**SUBSURFACE SOIL INVESTIGATION
WINDINGWALK FILINGS 1 AND 2 AND
STONEBRIDGE THE ENCLAVE FILINGS 4 AND 5
STAPLETON DRIVE AND EASTONVILLE ROAD
EL PASO COUNTY, COLORADO**

November 8, 2017
Revised December 21, 2017

TEST BORING LOCATION PLAN
WINDINGWALK FILINGS 1 AND 2, AND
STONEBRIDGE THE ENCLAVE FILINGS 4 AND 5
EL PASO COUNTY, CO.
FOR: TECH CONTRACTORS

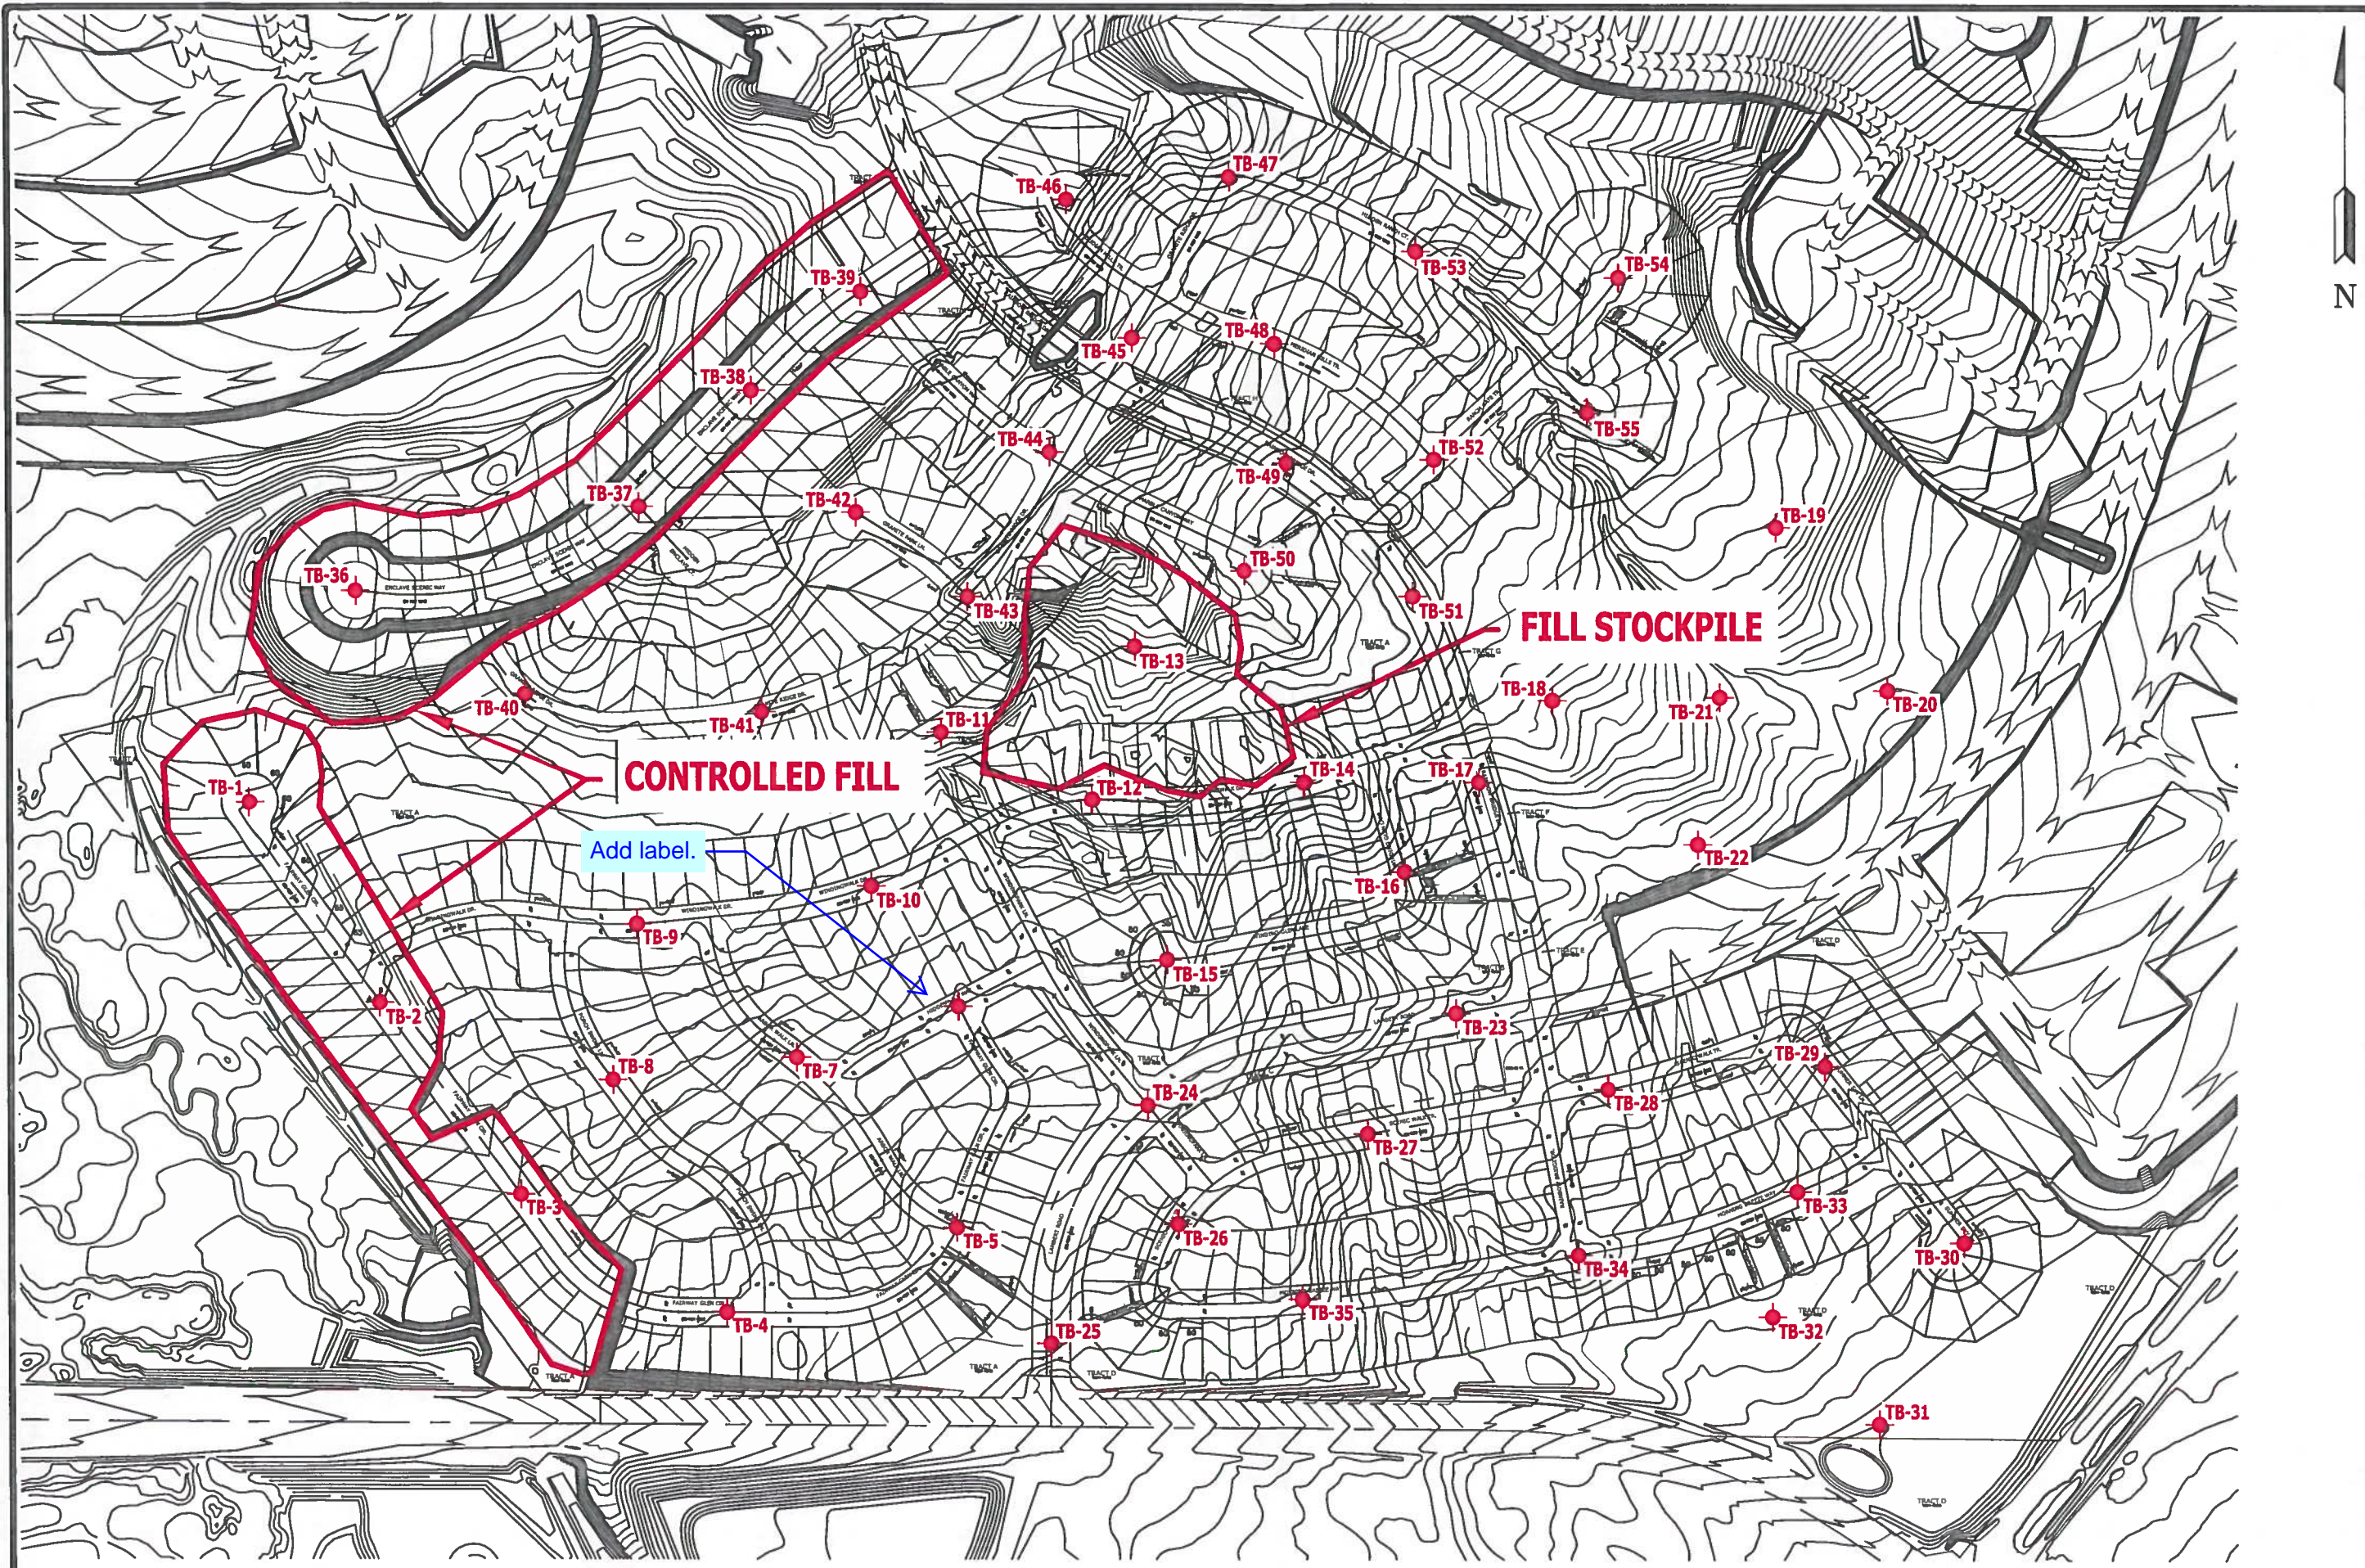
Please show the approximate range of each soil type on the exhibit. Unresolved. Provide an exhibit showing the approximate band (area) of the different soil types.

please add all of this type of information to a
single figure, typical all.
**Unresolved. Provide an exhibit showing the
general area where shallow ground water is
expected.**

Information depicted on Figures 2 & 2A

Information depicted on
Figures 2 & 2A
